**Freightliner
Service Bulletin**

Cascadia EPA10 vehicles with a Detroit 1-Box aftertreatment device may experience engine-induced derate. If the MIL light illuminates, and the derate occurs in conjunction with engine-related fault codes, this condition may be due to wear or damage to the aftertreatment electrical harness. Use the instructions in this bulletin to inspect, and if necessary, replace the harness.

New service harnesses are available for Cascadia EPA10 vehicles with Detroit 1-Box aftertreatment devices. The new harnesses feature friction tape and heat sleeves, instead of corrugated conduit. These harnesses also have additional length, to allow them to be routed along the back-of-cab crossmember.

Fig. 3, Aftertreatment Harness Installed Away from the Frame

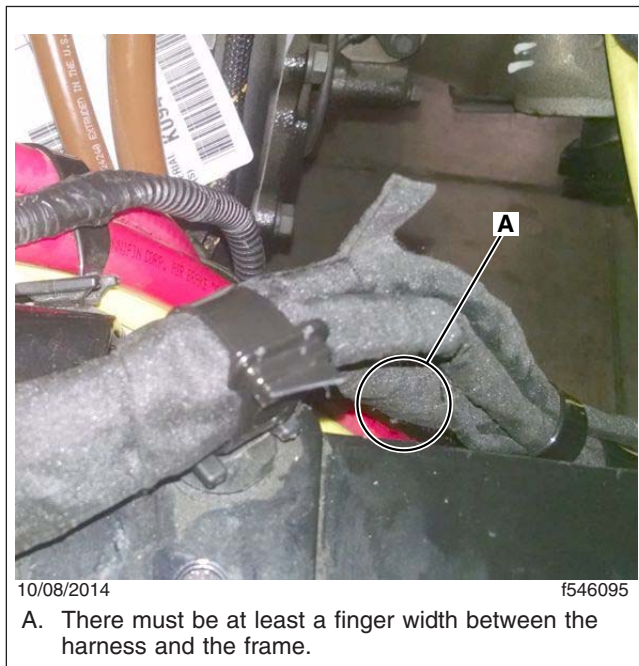
1. Park the vehicle on a level surface, shut down the engine, and set the parking brake. Chock the tires.
2. Inspect the aftertreatment harness.
 - 2.1 Check the harness around the area of the frame rail, the crossmember, and the air lines.
 - 2.2 Make sure that the harness is not worn through, and that the wires are not exposed or damaged.
 - 2.3 If the harness is damaged, continue with these instructions.
3. Disconnect the batteries.
4. Disconnect the harnesses from the ACM and the DEF tank, then remove the harnesses.
5. Route the new aftertreatment harness. See [Fig. 1](#). Make sure that there is no contact with sharp edges. See [Fig. 2](#) and [Fig. 3](#).
6. Secure the harness away from the air lines using part number TYC DCT110HIR. See [Fig. 4](#).

Fig. 7, Harness Secured at the DEF Tank

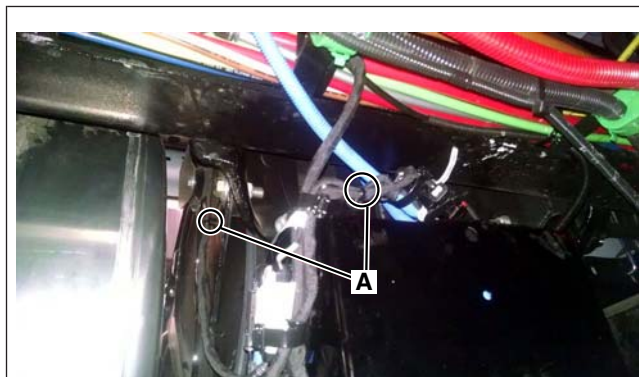
7. Loop any excess harness and secure. See [Fig. 5](#).
8. Secure the harness in the crossmember, including any excess, using nylon cable ties, part number 23-12069-001. See [Fig. 6](#).
9. Secure the harness at the DEF tank and the pump brackets using part number 23-13481-000. See [Fig. 7](#). Allow enough slack to account for transmission movement. See [Fig. 8](#).

- A. Use push-on tie straps, part number 23-13481-000, to secure the harness.
